**Monks Orchard Residents'
Association
Planning**

14th September 2023

TOWN AND COUNTRY PLANNING ACT 1990
Appeal (W) under Section 78
Location: 19 Orchard Avenue CR0 7NA
LPA Application Ref: 22/02022/FUL
Appeal Ref: APP/L5240/W/23/3318923
Consultation Close: 28th September 2023

PTAL Linear incremental increase in proportion with increase in Residential Density in relation to Area Type Setting

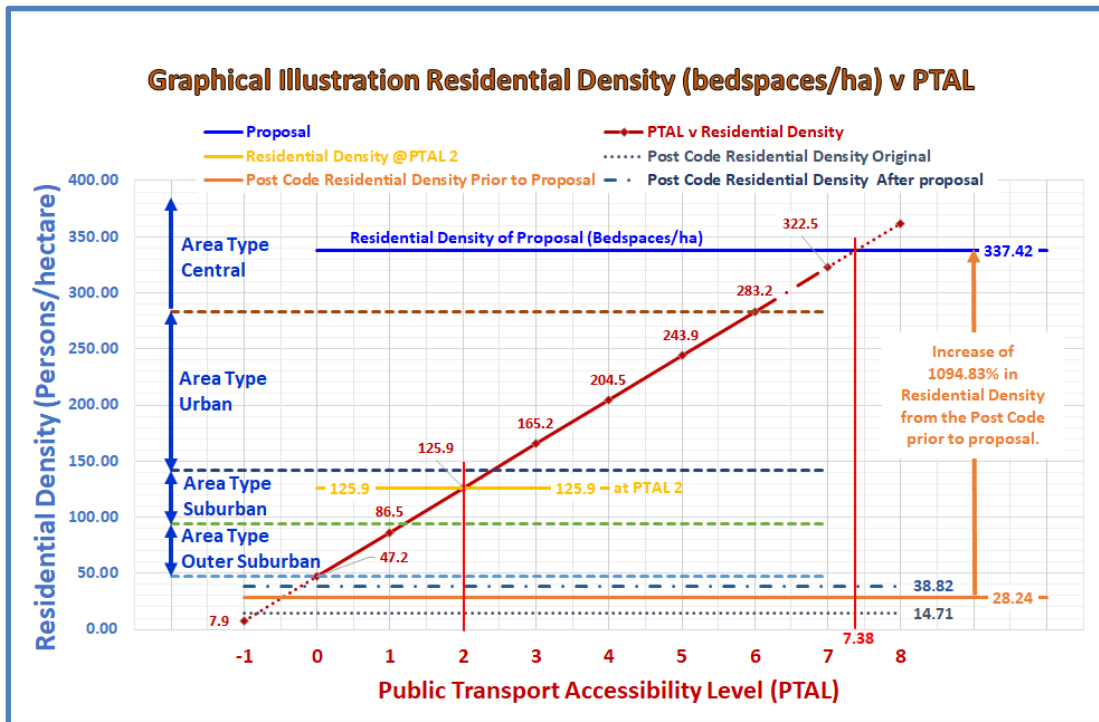
2.6.5 Therefore, the **Public Transport accessibility Level (PTAL)** for the proposal at a **Residential Density of 337.53 Bedspaces/ha** would be:

$$y = \text{Residential Density} = \left(\frac{120 * 2.36 - 20 * 2.36}{6} \right) * x + 20 * 2.36$$

$$\therefore x = \text{PTAL} = \frac{337.53 - 47.2}{39.33} = \frac{290.33}{39.33} = 7.3818 \approx 7.38 = \text{PTAL}$$

2.6.6 The Graphical illustration above shows the **Residential Density** increase of **1094.83%** from the **Post Code Residential Density** of **28.24 persons/ha** to **337.42 persons/ha** of the proposal. This Proposed **Residential Density** of **337.42 persons/ha** would require a **PTAL of 7.38** when the available PTAL for the locality is **PTAL 2**, and not proposed to be improved before 2031.

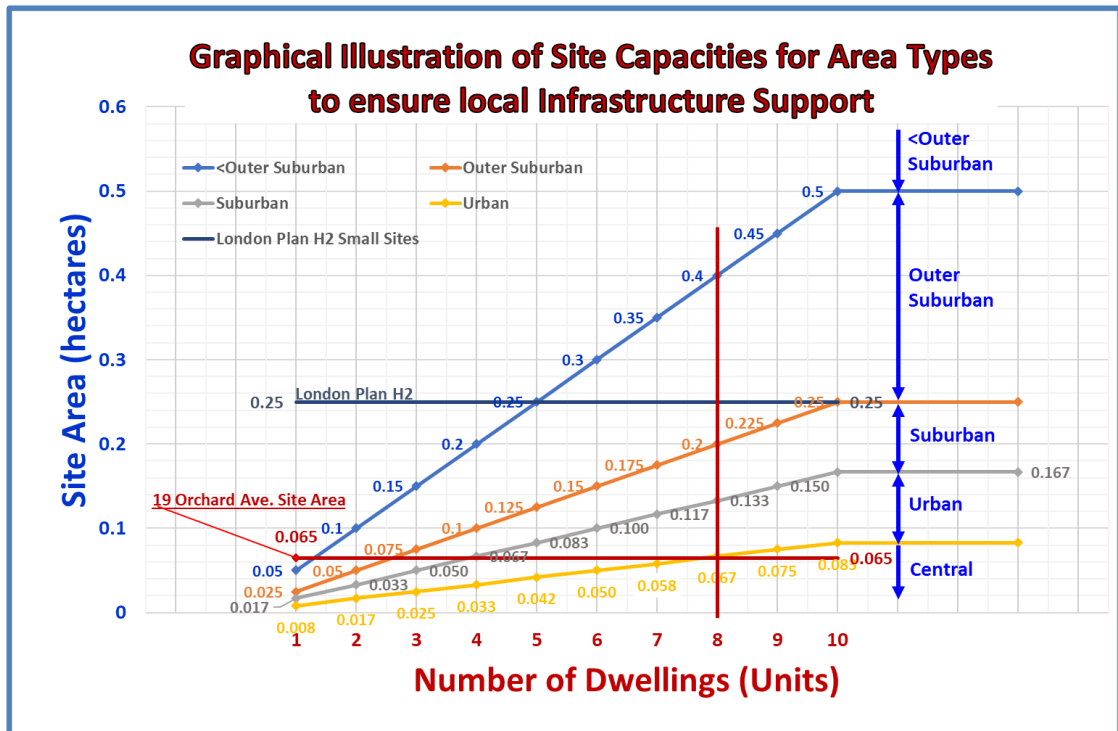
2.7.6 The **Garden Areas** are assessed by analysis of the **Plot Area Ratios (PAR)** for the different **Area Types** to provide an acceptable Garden/Green area in keeping with the locality and the **Area Type** with an assessment of the likely **Urban Greening Factor (UGF)**. All other areas required for **Parking, Cycle Storage** etc., are as found from web searches or the **London Plan**.

Figure 4.6 Example code for rear building line projection of dwellings in a semi-detached character type (such as *Metroland Estate*)

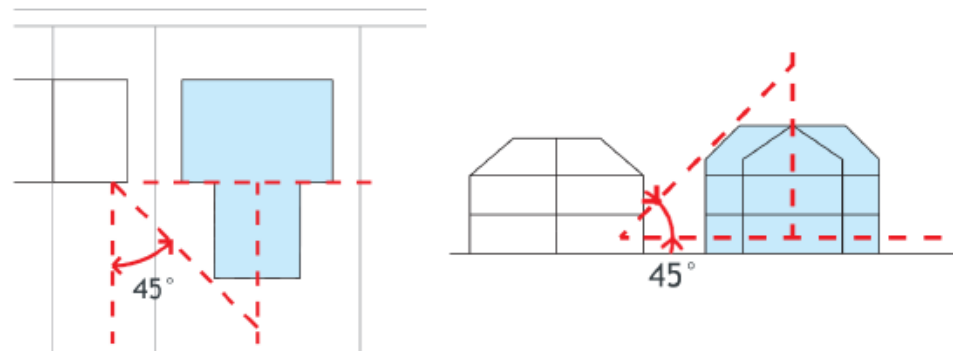
4.2.1.3 Although SPD2 was revoked in 2022, the **London Plan Supplementary Planning Guidance Small Site Design Codes** first published in **February 2021** for consultation and subsequently adopted in 2022 included the 45 °Degree Rule on neighbour amenity at **Section 4.5 Rear Building Line Projection** (Figure 4.6).

45°Degree projection Rule from centre of nearest Ground Floor Window of adjacent dwelling

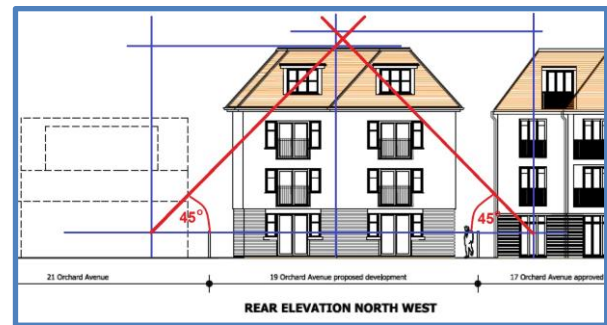
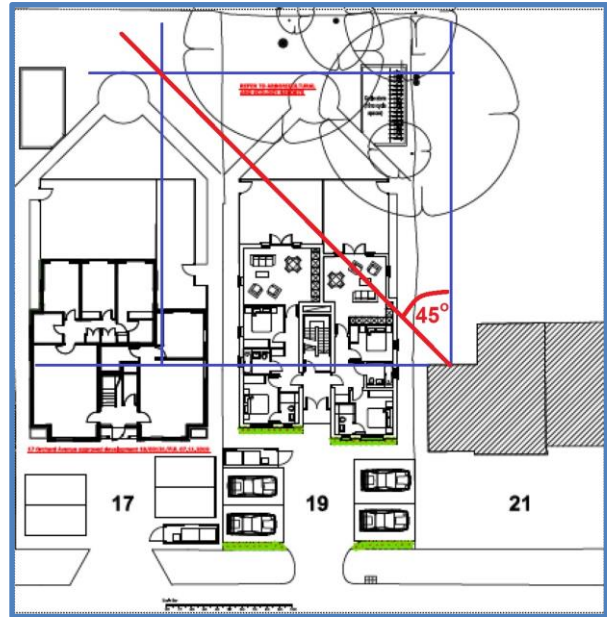
4.2.1.4 Therefore, although SPD2 was revoked in 2022 the **London Plan Policy** overlapped and provided the same guidance on neighbour amenity. The proposal **Fails** this policy for both **horizontal** and **vertical 45°Degree projection**. The appellant has NOT provided any evidence to disprove this assessment.

4.2.1.5 We therefore are confident that the LPA assessment was correct in that *“The proposal, by reason of its massing and proximity, would result in an intrusive and imposing form of development detrimental to the visual amenity and outlook for neighbours at 21 Orchard Avenue contrary to policy DM10 .6 of the Croydon Local Plan 2018 and Policy D3 of the London Plan 2021”* and that the proposal **fails the 45°Degree Rule** both **horizontally** & **vertically** thus supporting the **Reason 4** for Refusal. **Therefore, the Appeal should be Dismissed.**

Figure 6 - No.17 approved scheme compared with No.19 current proposal.

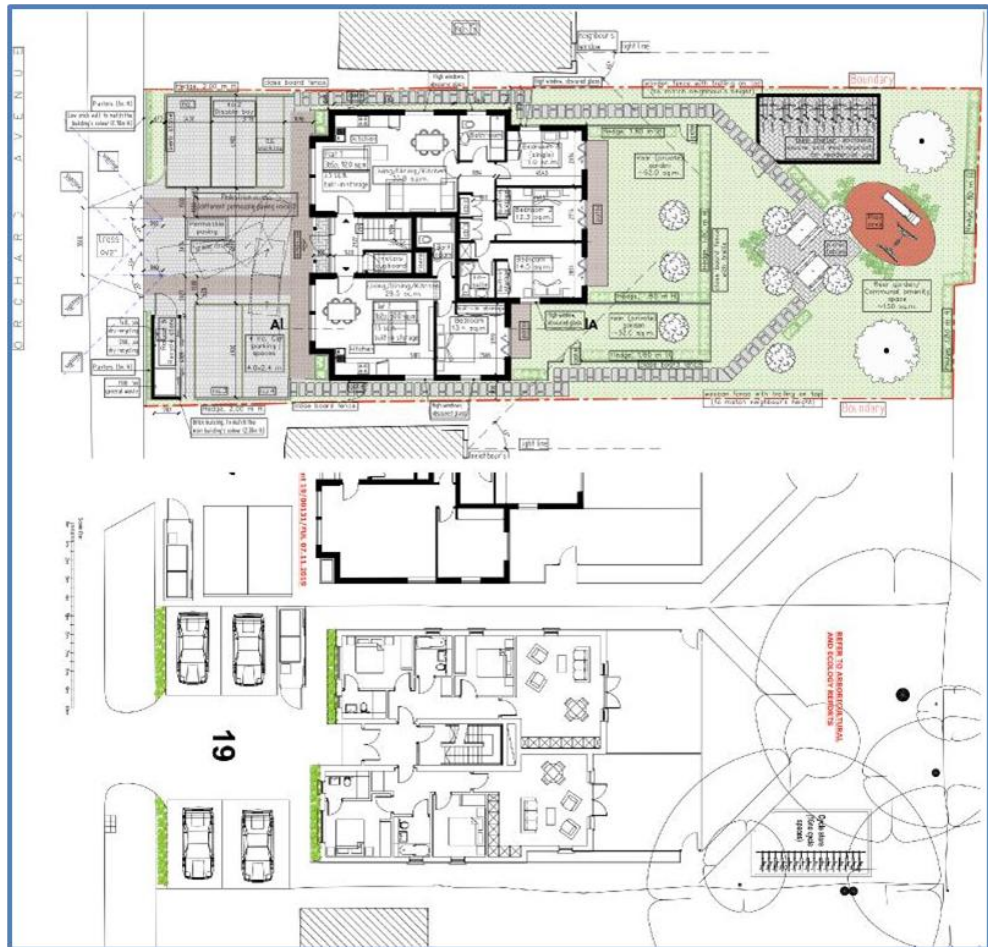
- 4.37. The proposed block plan 199/PA/108 confirms that the refuse collection provision is consistent with that approved in relation to the redevelopment of No.17. The bin store can accommodate a 1280l dry recycling bin, a 1280l general waste bin and a 140l food recycling bin for shared use by the residents. The bins will therefore be able to accommodate the required capacity per flat of 130-150 litres for general waste, 128 litres for dry recycling and 9.6 litres for food recycling.
